Comhairle Chontae Atha Cliath Theas

Record of Executive Business and Chief Executive's Order

Reg. Reference: SDZ22A/0006 **Application Date:** 13-Apr-2022
Submission Type: Additional **Registration Date:** 01-Sep-2022
Information

Proposed Development: Construction of 352 residential units (terraced, semi-detached and detached) comprising 253 two storey houses (15 two bed units and 238 three bed units ranging in size from c. 86sq.m to c. 118sq.m) and 99 three storey houses (18 three bed units and 81 four bed units and ranging in size from c. 147sq.m to c. 189sq.m); The total gross floor area of the development is c. 43,272sq.m; The development will also comprise the provision of 2 vehicular accesses from Adamstown Boulevard, 1 vehicular access from Adamstown Drive (L1030), 2 vehicular accesses from Adamstown Park Road and 2 vehicular accesses from Tandy's Lane; vehicular connections will also be provided to permitted roads in Tandy's Lane Phase 1; internal routes; 535 car parking spaces including on-curtilage and off-curtilage spaces; bicycle parking; bin storage; plant; ESB Substations; boundary treatments; lighting; hard and soft landscaping; and all other associated site works

Figure 6 only left turn from development on west side

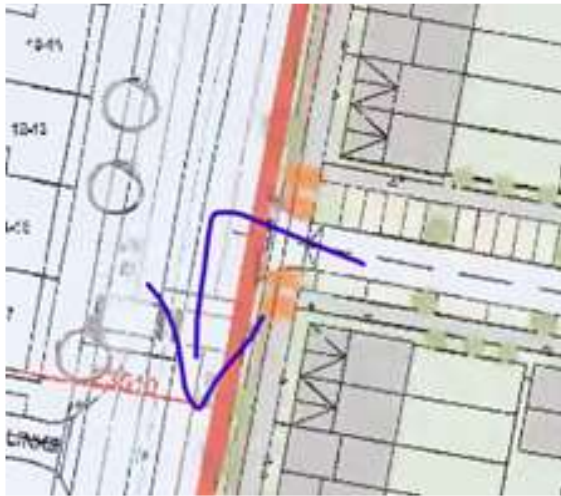
The west of the development will only have left out vehicle access, this has the potential to increased traffic to use the northern access locations as there is little vehicle permeability to the east and most of the desire lines are towards the Newcastle Road and the N4.

Figure 8 parking on a bend

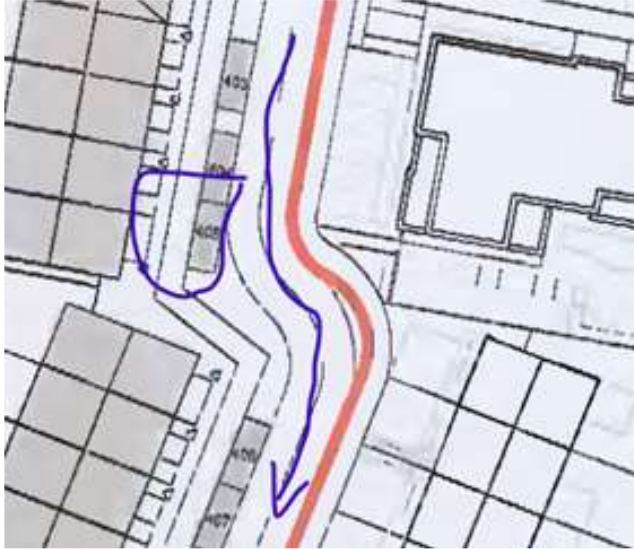
The TII have recommended a road safety audit to identify the roads issues within the development, SDCC roads department concur.

Figure 9 how are these space on curtilage.

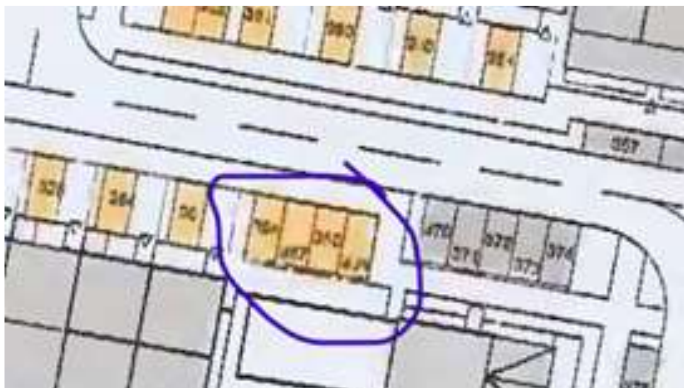
The parking spaces identified in Figure 9 are shown as in curtilage, it is not clear if these spaces will be in the public domain or not and could result in confusion regarding private parking spaces and public off curtilage spaces that have been taken in charge. policy 2.4.22 of the Adamstown SDZ "no more 60% offer residential car parking spaces shall be provided as private In-Curtilage parking spaces in any development area. "

- 5. The applicant is to submit details of a the in-curtilage parking spaces to be within the boundary of private areas.*
- 6. The applicant is to submit details of a roads layout that matches the layout as proposed in the SDZ area masterplan.*

(a) *Figure 1 cross section through homezone*

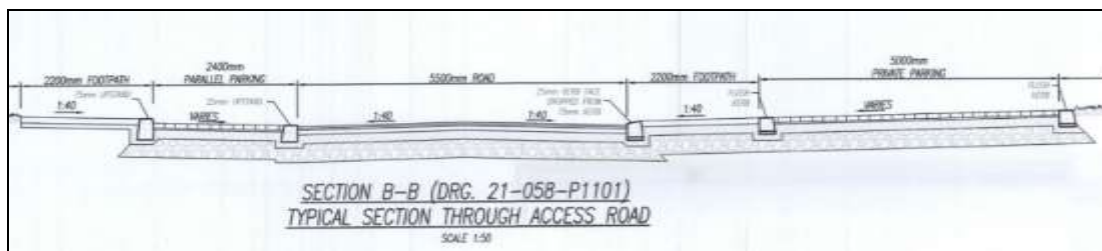
The applicant has submitted a cross section through the home zones detailing 4.5m carriage way and 1.5m refuge giving a 6.0m reversing space.

Figure 3 access road

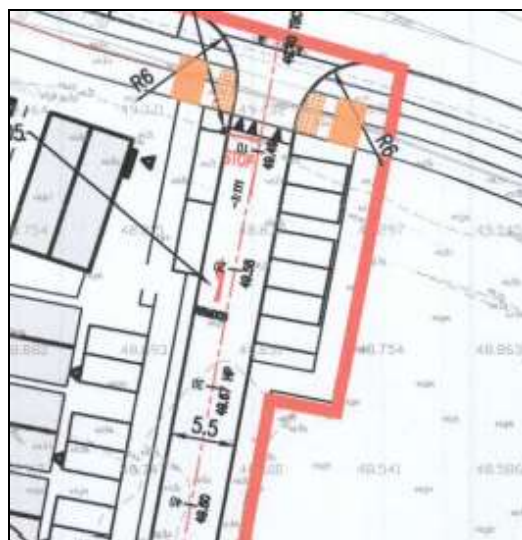
The applicant has submitted cross sections of roads, access road and homezone. The access road cross section does not match the layout plan, Figure 2. The footpath is behind the parking spaces
